Unit Managers' Meeting: 300 Areas Remedial Action Unit/Source Operable Units

Meeting Minutes Transmittal/Approval
300 Area Unit Managers' Meeting
Remedial Action and Waste Disposal Unit/Source Operable Unit
3350 George Washington Way, Richland, Washington
September 2002

**MEETING MINUTES
REMEDIAL ACTION AND WASTE DISPOSAL
UNIT MANAGER'S - 300 AREA
Tuesday, September 17, 2002
3350 GWW, 1B45, 1:30 – 3:30 P.M.**

STAGING PILE LOCATIONS

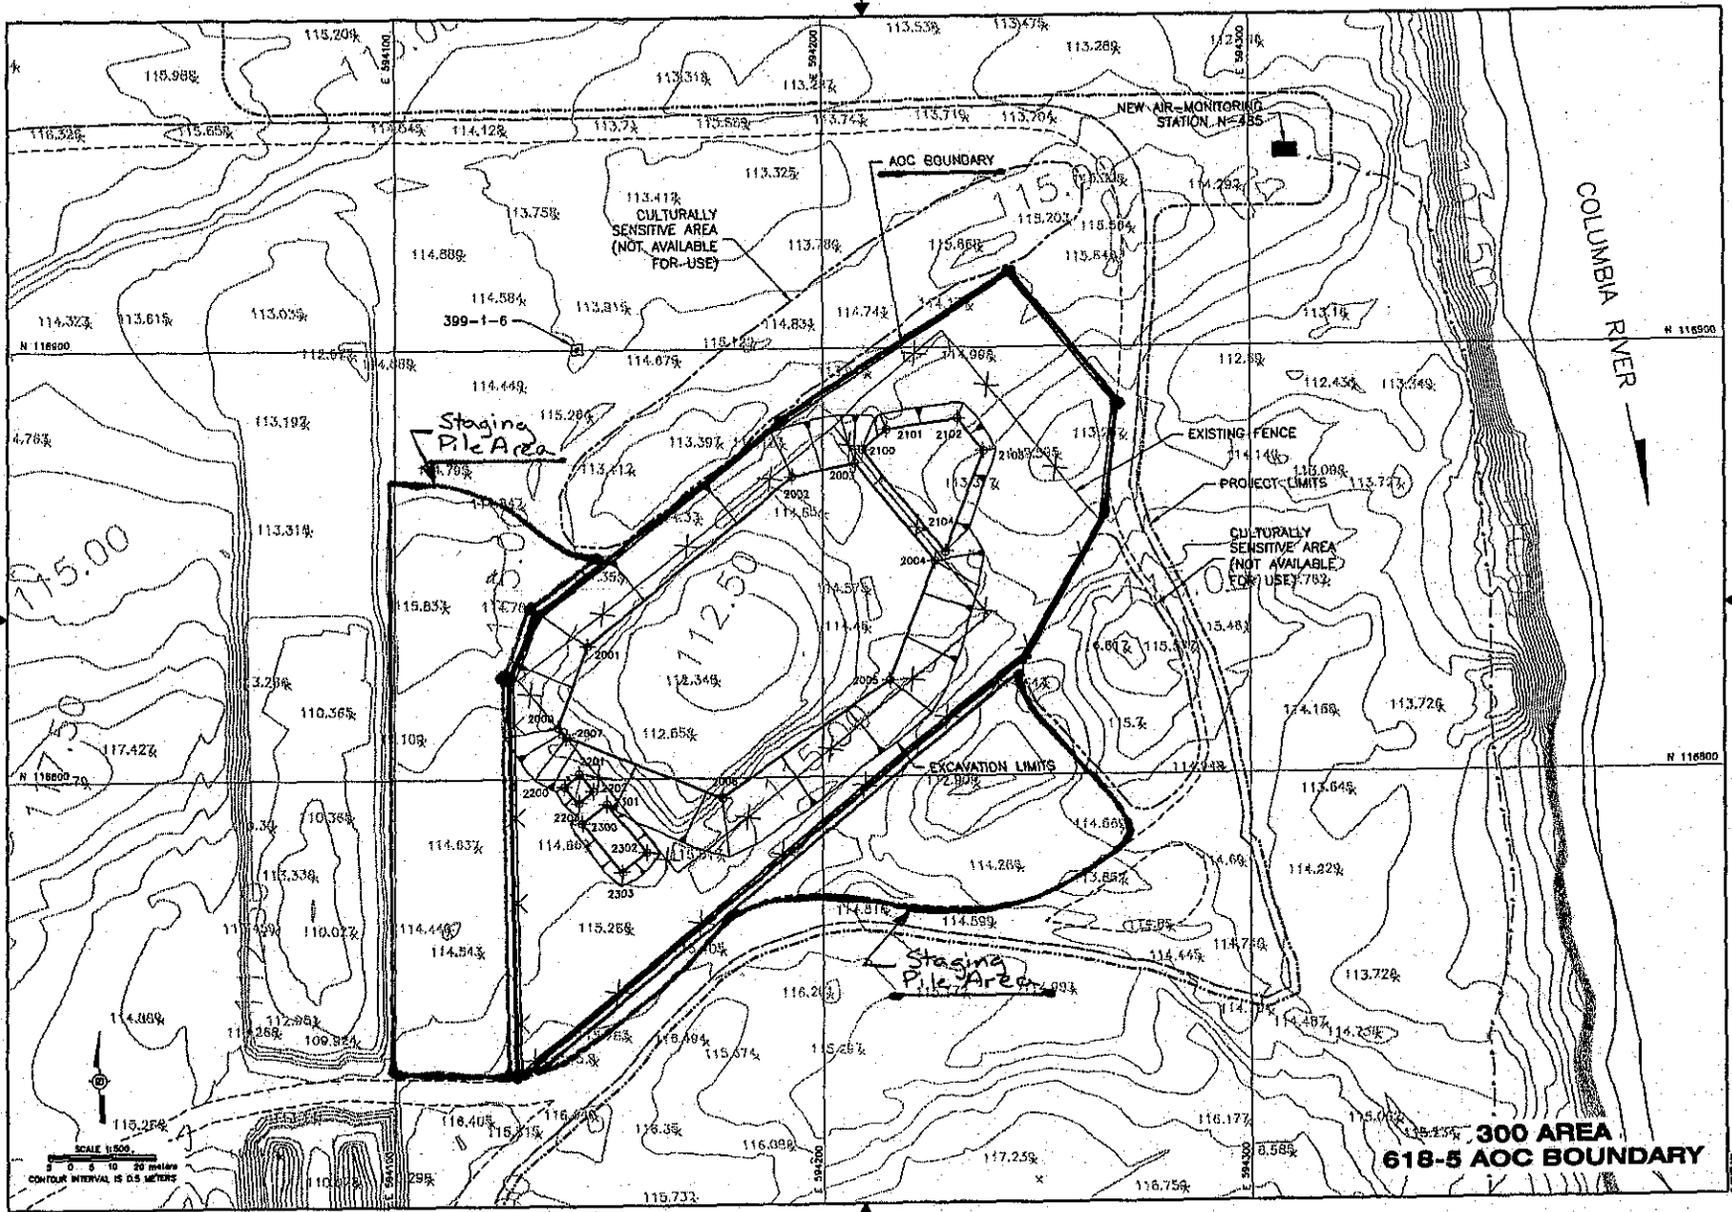
With this sentence added, I concur with everything in the "controls" section except the first sentence of the last bullet. My issue is that the purpose of the biased and random sampling is not to verify "compliance with cleanup objectives," but rather to verify "that the staging area is clean (i.e., has not been contaminated through use) and therefore does not require any long-term institutional controls." This is especially relevant to this location as it has been certified as "clean closed" with respect to chemicals via the RCRA closure process.

Also, with regard to the e-mail Jack sent out that describes the rationale for why we are using the staging pile regulations as opposed to simply expanding the area of contamination, I am curious to hear Bechtel's interpretation of how the requirements outlined in 264.554 for "closing" a staging pile sited in an uncontaminated area (which cites sections 264.258(a) and 264.111) and public notification are being met as well.

That being said, I have no problem with you proceeding to use the designated staging pile areas using the language contained in the controls section of this draft (with the exception noted above). If we modify the rationale or other language in the RDR/RAWP as a result of the other questions I have asked, it will not affect my approval of the procedure you have outlined in this attachment (except as noted).

- The staging pile area will be surrounded with a minimum of a 15-centimeter (6-inch) berm to control run-on/run-off control prior to use.
- The staging pile area to the west of 618-5 burial ground will be utilized first and EPA approval will be obtained prior to using the area to the south of 618-5 burial ground.

- Following removal of the staging piles, bias and random samples will be collected consistent with the Sampling and Analysis Plan (SAP) (DOE/RL-2001-48) to verify compliance with cleanup objectives. Bias samples will be collected at locations where staging piles existed and will be analyzed for constituents that were present in the associated staging piles. For random samples, the staging pile area shall be considered a shallow zone decision unit in accordance with the SAP. The decision unit will be divided into subunits based on size and the prescribed number of random verification samples will be collected (Table 3-3), excluding any general areas that were unused during operation of the staging pile area. Verification samples will be analyzed for the site Contaminates of Concern (COCs) and results will be compared with the 300-FF-2 cleanup levels and documented in the Cleanup Verification Package (CVP) to demonstrate that remedial action objectives have been achieved. The closeout approach for the staging pile area will be presented and agreed to in a UMM.
